SYS-01

ILLINOIS DEPARTMENT OF TRANSPORTATION
 F.A.I. 94/90 (DAN RYAN EXPRESSWAY)
 31st STREET to I-57
 DYNAMIC MESSAGE SIGN SUBSYSTEM
 SCALE: 1"=2000'
 DATE: October 29, 2004
 DRAWN BY: CH
 CHECKED BY: MJL

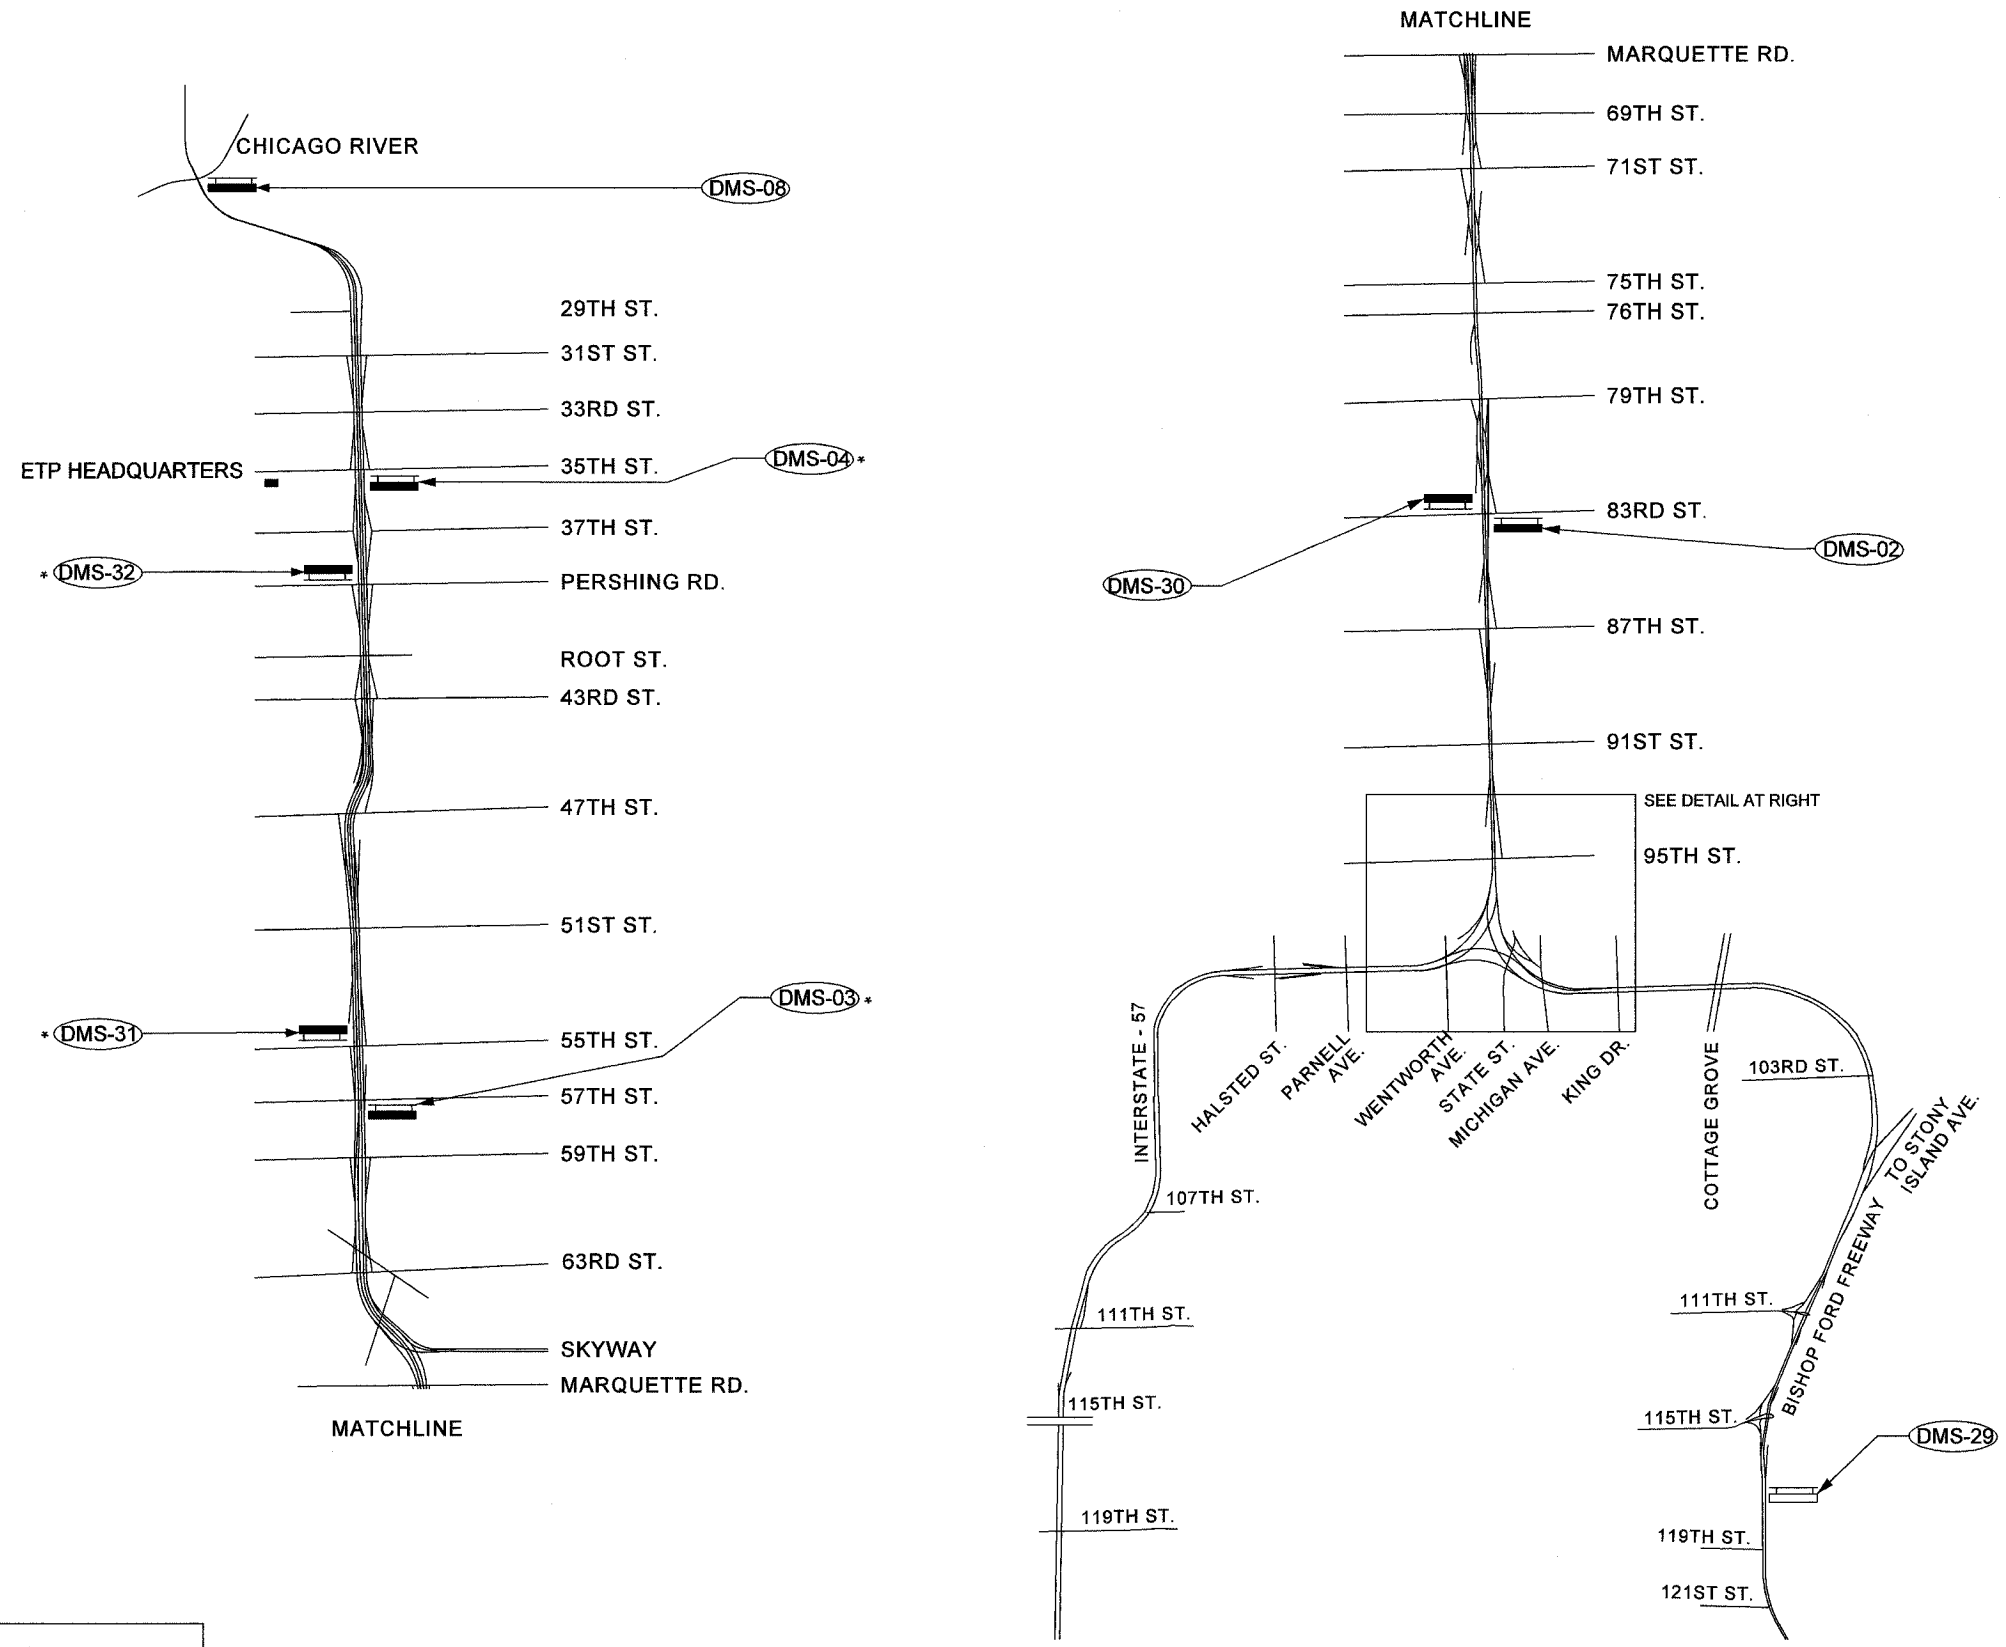
NOTE:
 * DMS-03, DMS-31, DMS-32, DMS-04 ARE SHOWN IN THESE PLANS AS INSTALLED ON BUTTERFLY TRUSSES. SITE PLANS FOR THESE DRAWINGS WILL BE MODIFIED BY ADDENDUM TO SHOW TWO SIGNS AT EACH OF THESE LOCATIONS INSTALLED ON SEPARATE FULL SPAN TRUSSES. ONE SIGN WILL BE POSITIONED OVER THE EXPRESS LANES AND ONE OVER THE LOCAL LANES AT EACH LOCATION.
